ADDENDUM 2

DATE: April 13, 2022

Contract: 22-C-00005; Executive Park Gravity Sewer Replacement

SHEET: C2.4

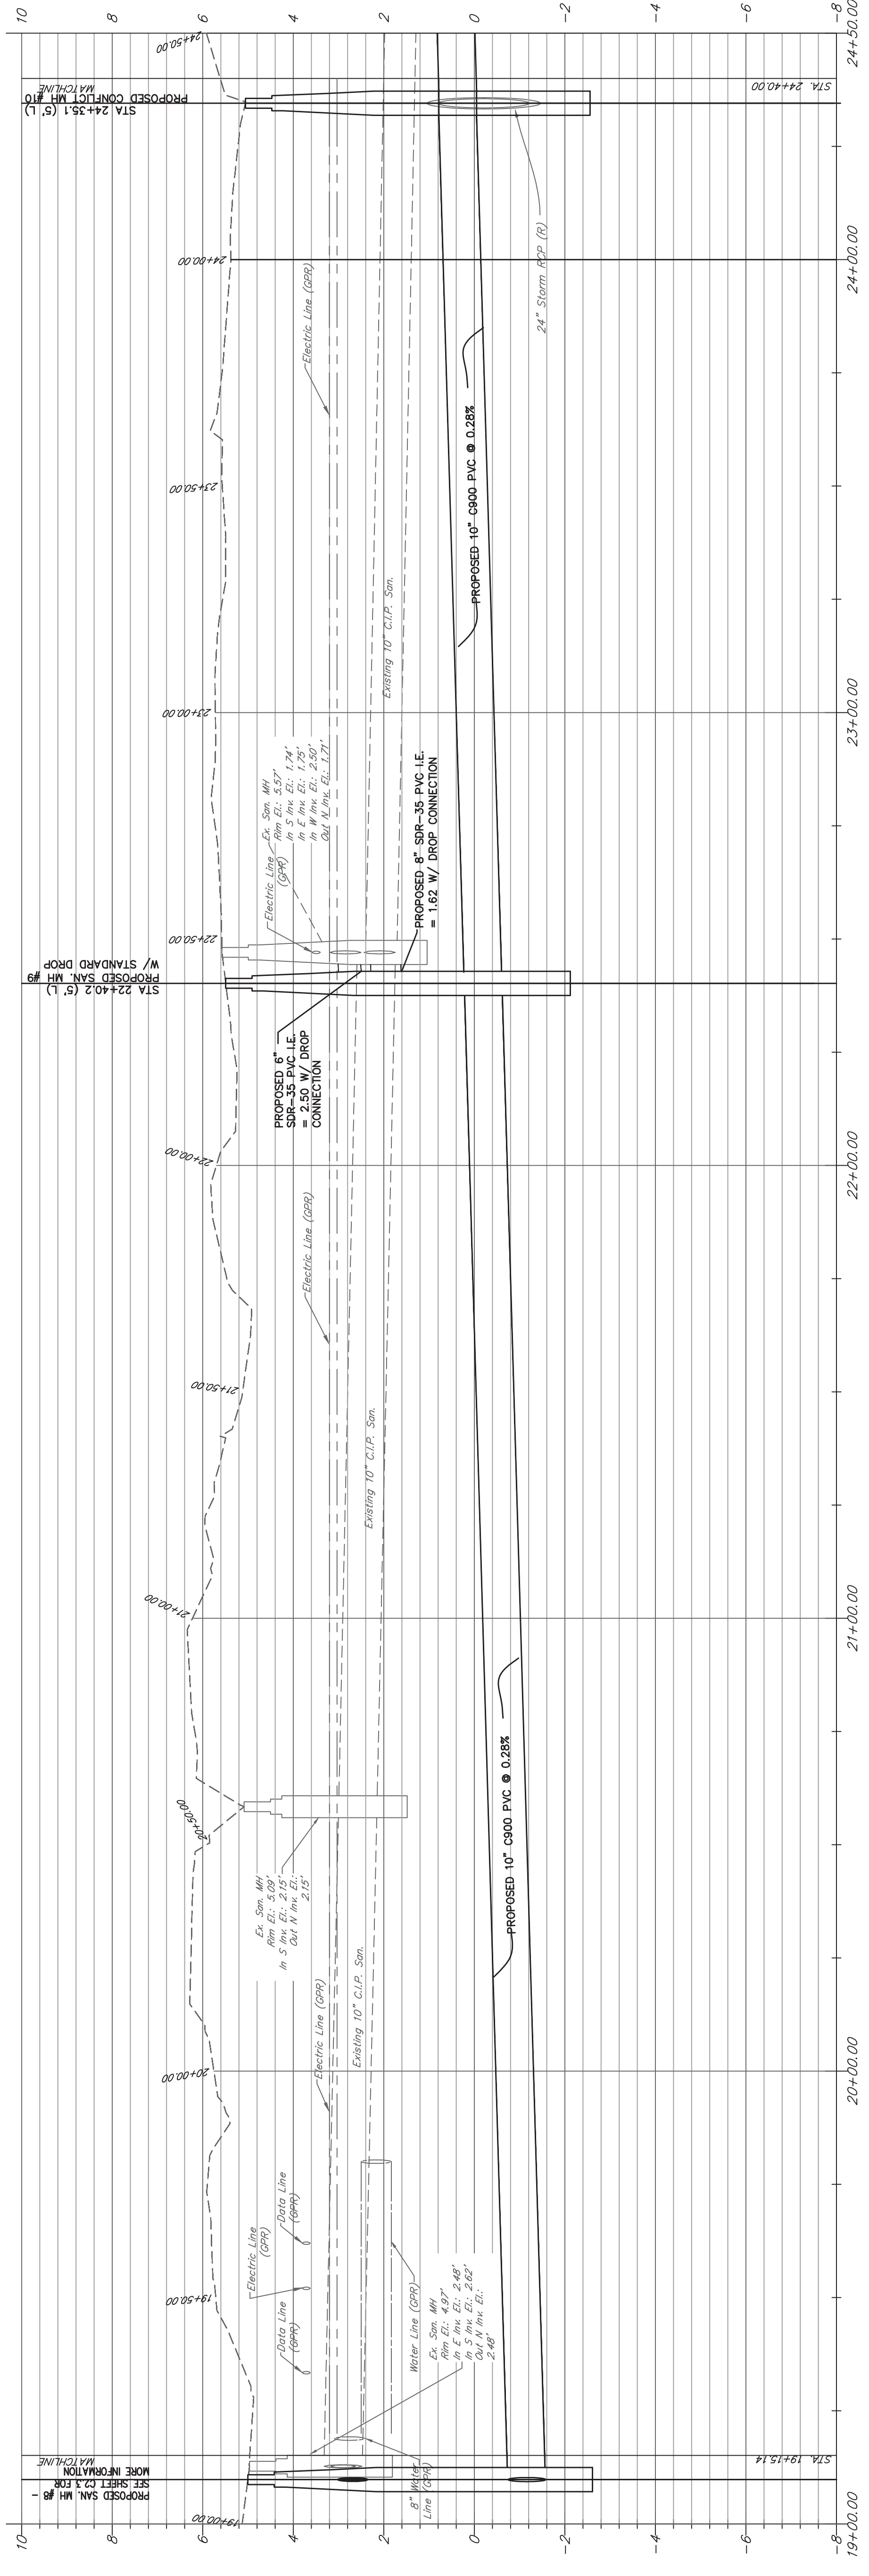
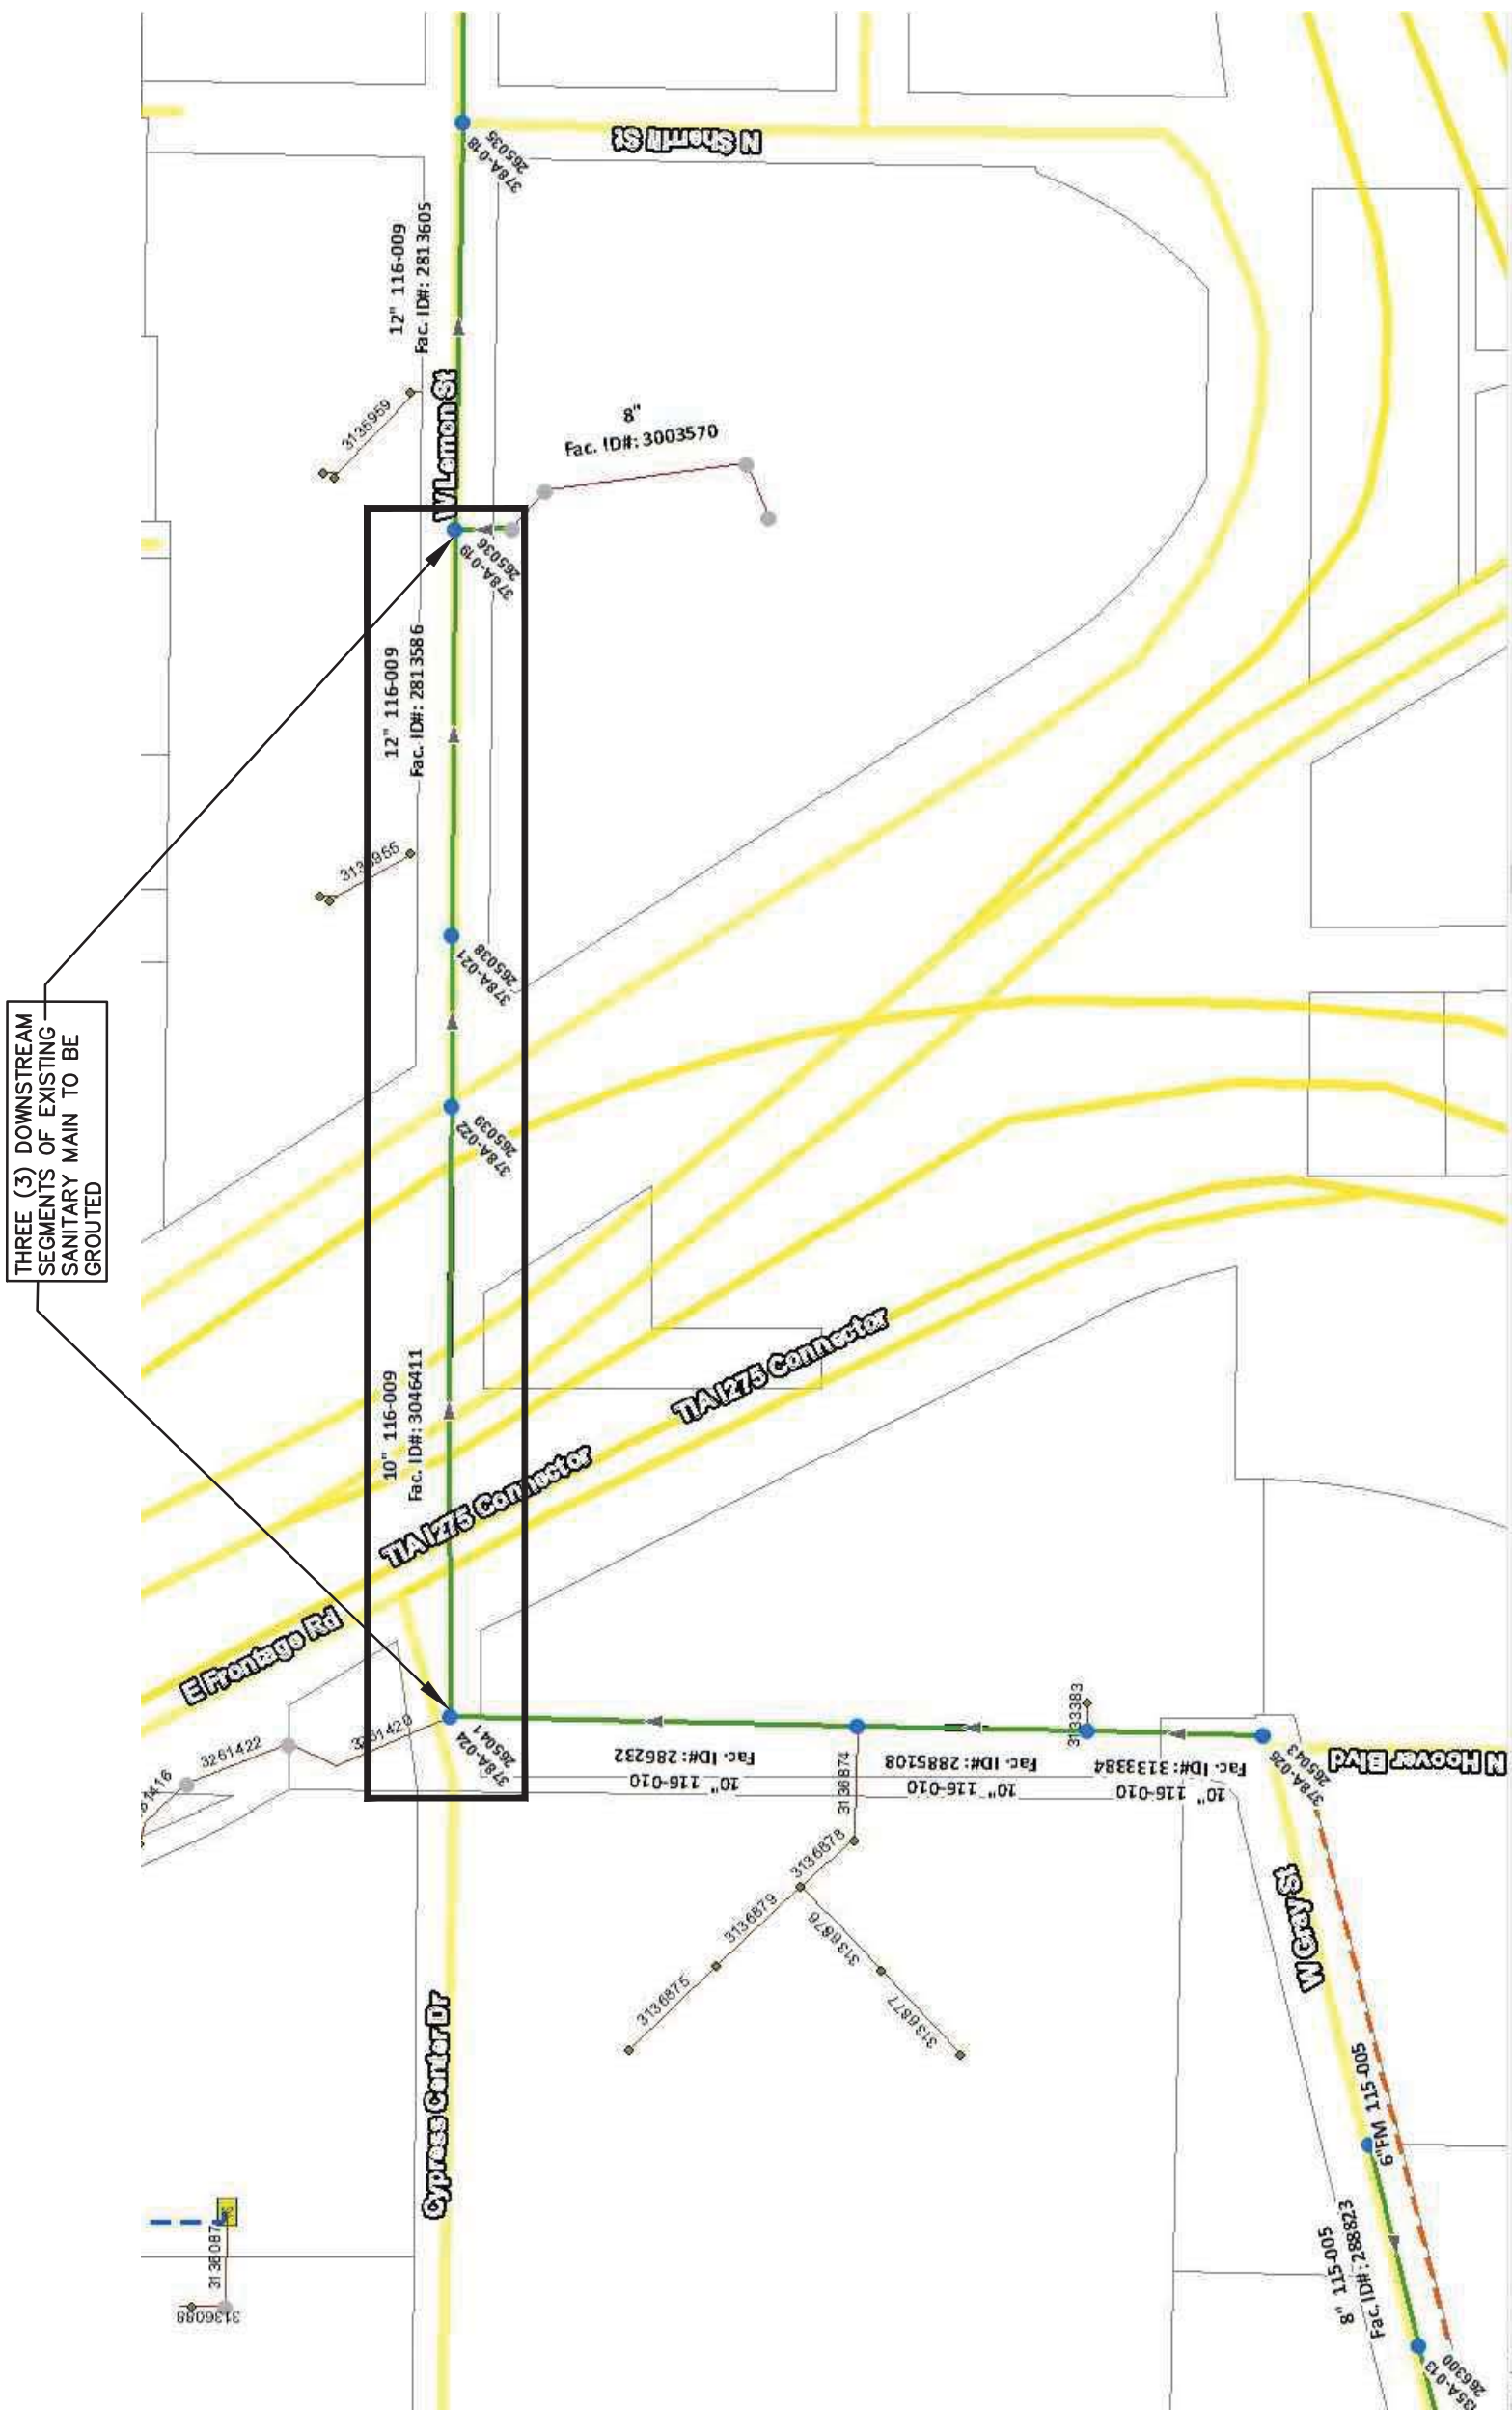
Item 12: Replace plan sheet nos. C2.4 and C2.5 with the attached plans sheet nos. C2.4 and C2.5.

BY	DATE	DESCRIPTION
CIV	1/13/22	10\"/>
